MITIGATION PLAN

COOL SPRINGS MITIGATION SITE

Harnett County, NC
NCDEQ Contract No. 0302-02
DMS ID No. 100166

Subject: Mitigation Plan
Cool Springs Mitigation Project, Harnett County
Cape Fear River Basin HUC 03030004
USACE Action ID No. SAW-2020-01400/DWR No. 20201279

1.3.1

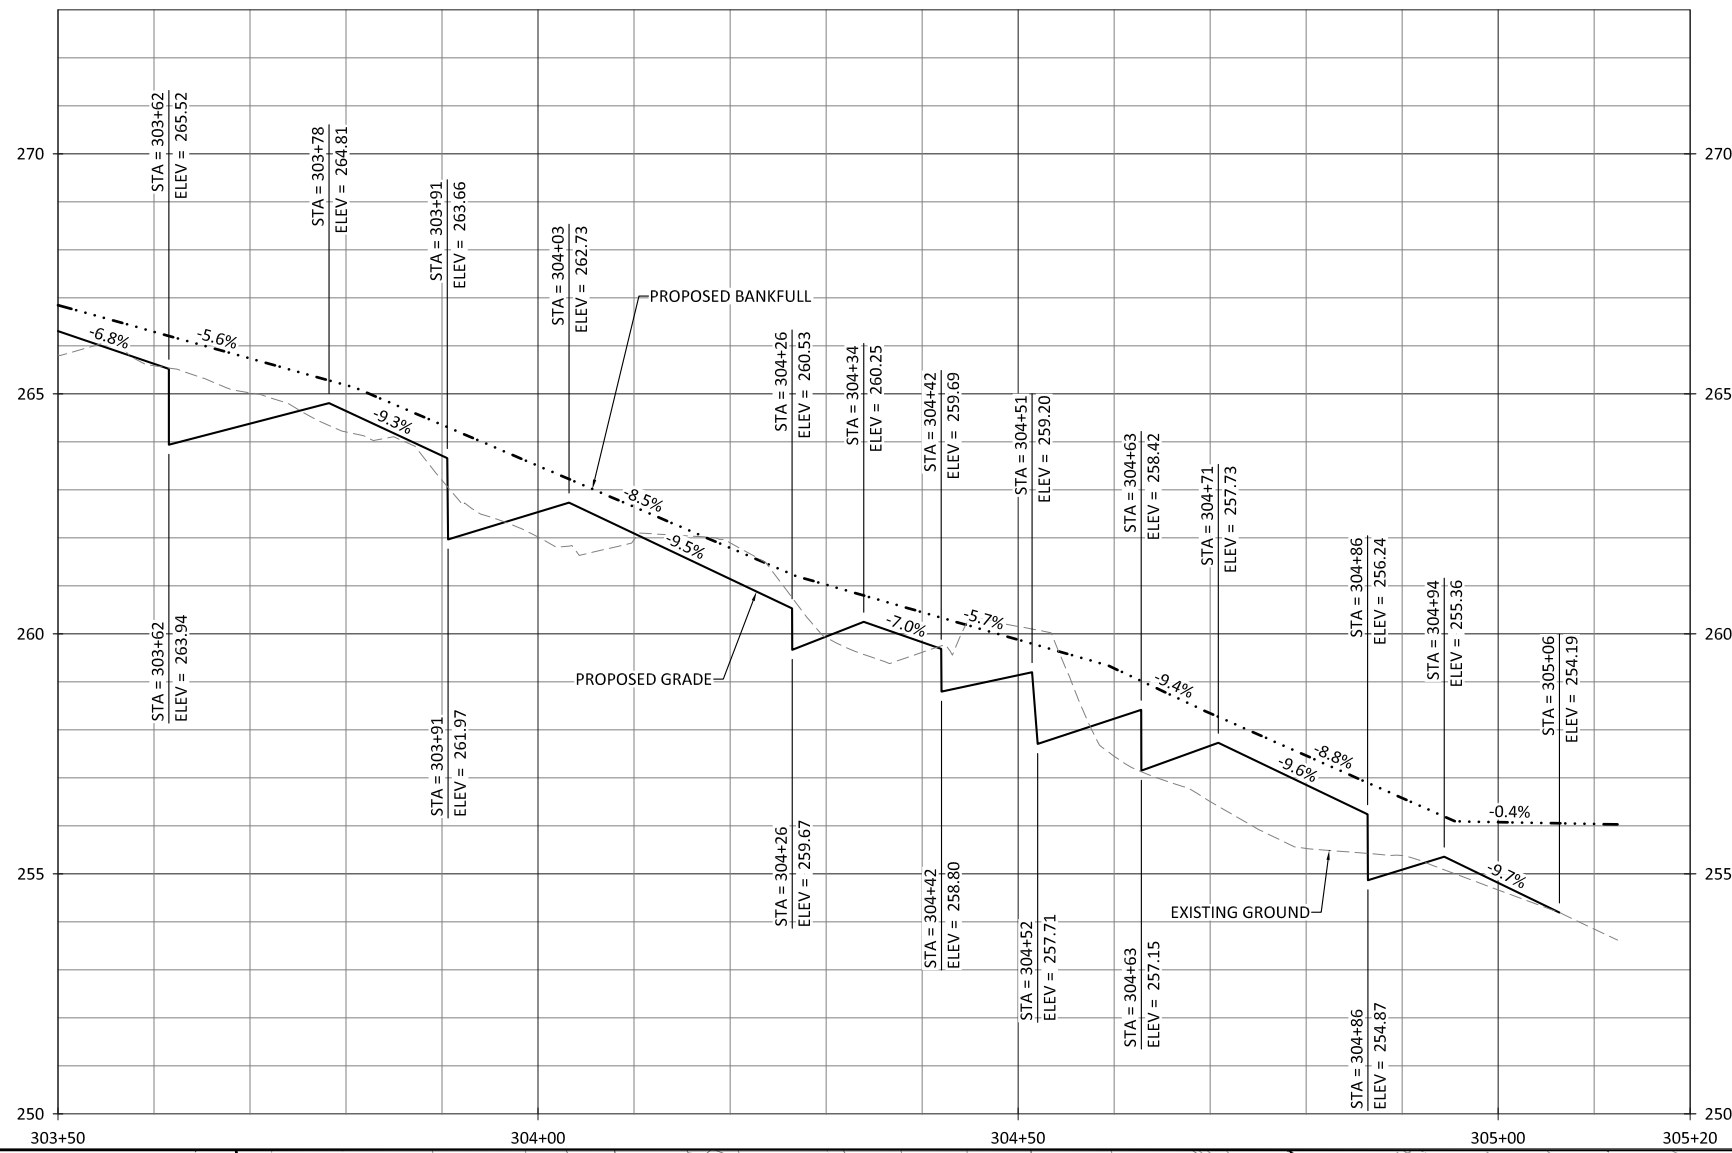
25. Sheet 1.3.1 – The first 250 feet of T2 is proposed to be raised 3-5 feet. Are there any concerns about this altering the flow regime?

Cool Springs Mitigation Site
 Harnett County, North Carolina
 BMP5 - VEGETATED SWALE
 BMPs

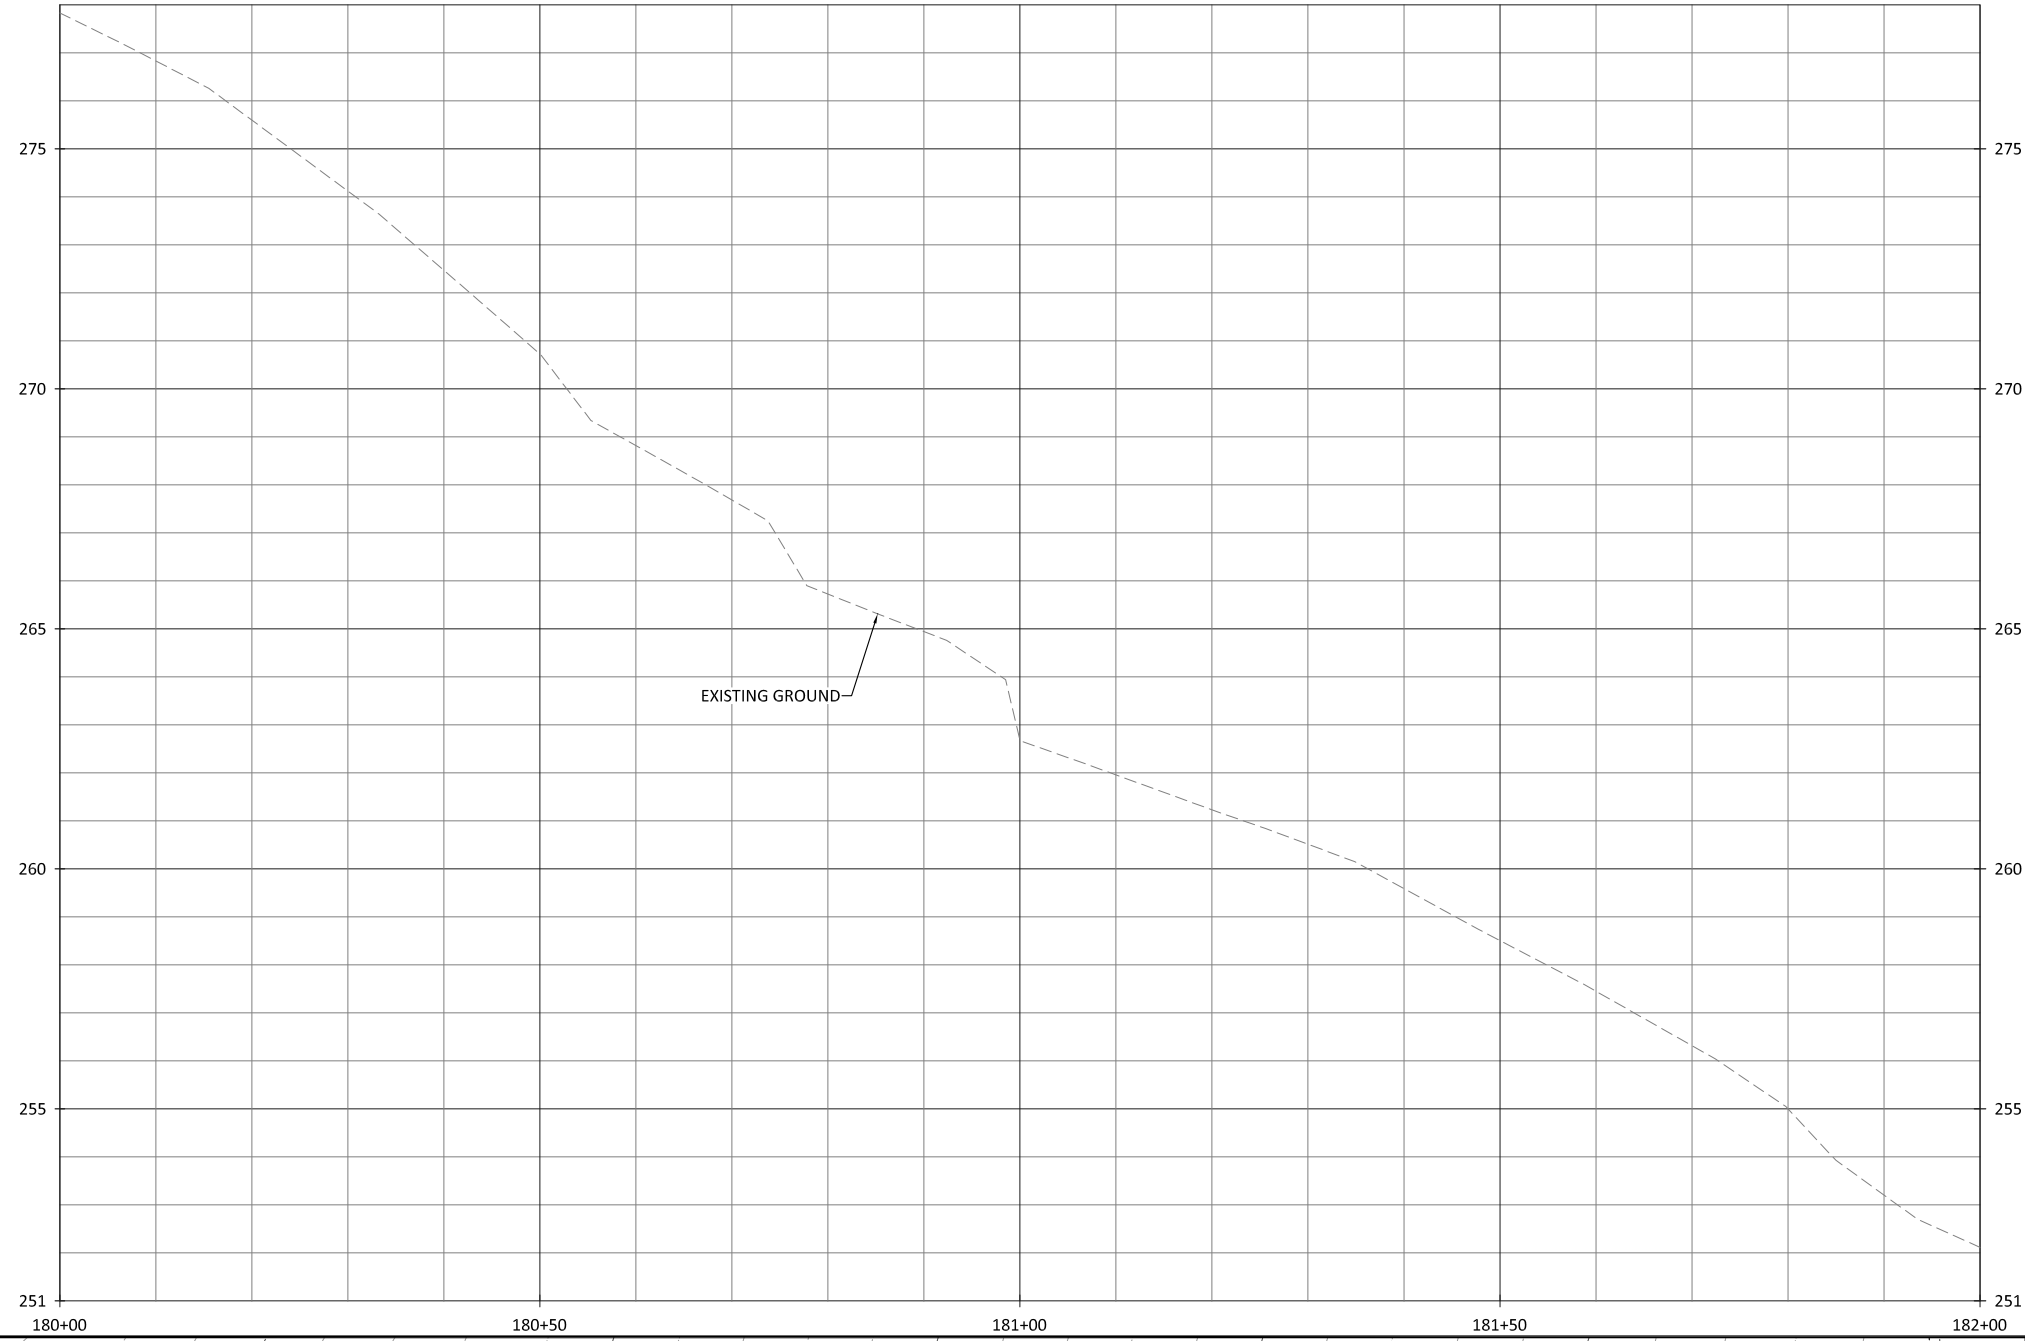
10. Design Sheet 2.6: BMP 5 appears to be placed in an existing wetland. Treatment areas should not be placed in jurisdictional waters. It appears that logs will be placed in wetland D. Please confirm that the BMP is not being placed in a wetland.

The stationing on the plan set has been updated to reflect that the BMP ends at the start of the wetland. Log sills will still be placed in the wetlands to stabilize an existing drainage feature and prevent further erosion and downcutting.
